UNITED STATES PATENT AND TRADEMARK OFFICE

APPLICATION NO.	FILING DATE	FIRST NAMED INVENTOR	ATTORNEY DOCKET NO.	CONFIRMATION NO.
10/622,784	07/21/2003	Kenji Utsunomiya	402716/SOGA	4261
23548	7590	08/04/2005	EXAMINER	
LEYDIG VOIT & MAYER, LTD 700 THIRTEENTH ST. NW SUITE 300 WASHINGTON, DC 20005-3960			SALATA, ANTHONY J	
			ART UNIT	PAPER NUMBER
			2837

Office Action Summary	Application No. 10/622,784	Applicant(s) UTSUNOMIYA ET AL.	
	Examiner Jonathan Salata	Art Unit 2837

Paper No:08022005
Application No:10/622784
Filing Date: July 21,2003

Fig. 1

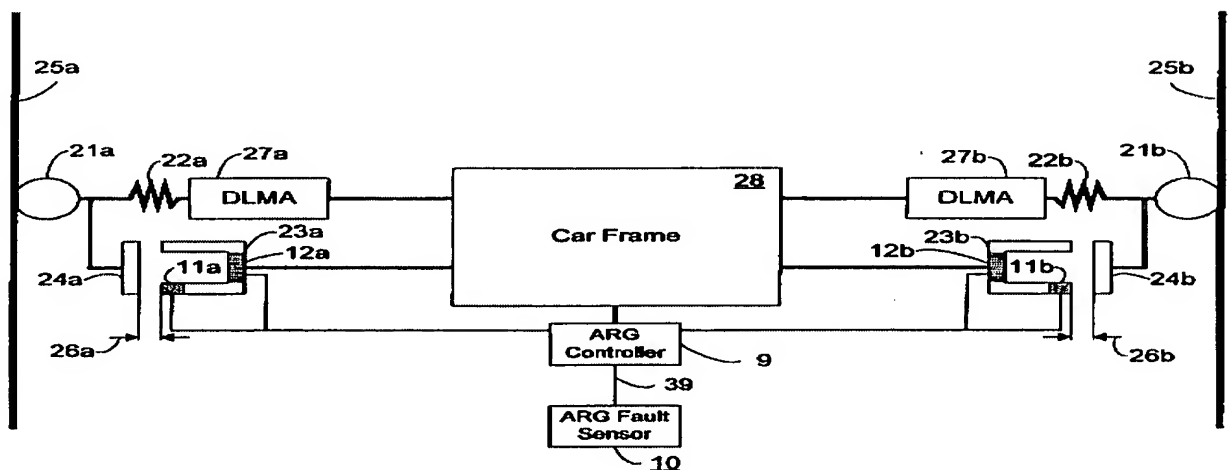
Jamieson et al teaches in figures 1-4, an elevator active guide fault sensor system.

A vibration magnet 23a,23b contains sensors 11a,11b which control actuators 27a,27b to center the car 28 in the shaftway horizontally. A detection sensor 10 compares the sensor values. If the values fall above a limit 51 the actuator is shut-off 52.

With respect to claim 1, the elements within the claimed invention appear to be shown within Jamieson. No requirements appear within the claim towards the type of sensor or control and their complexity or lack thereof.
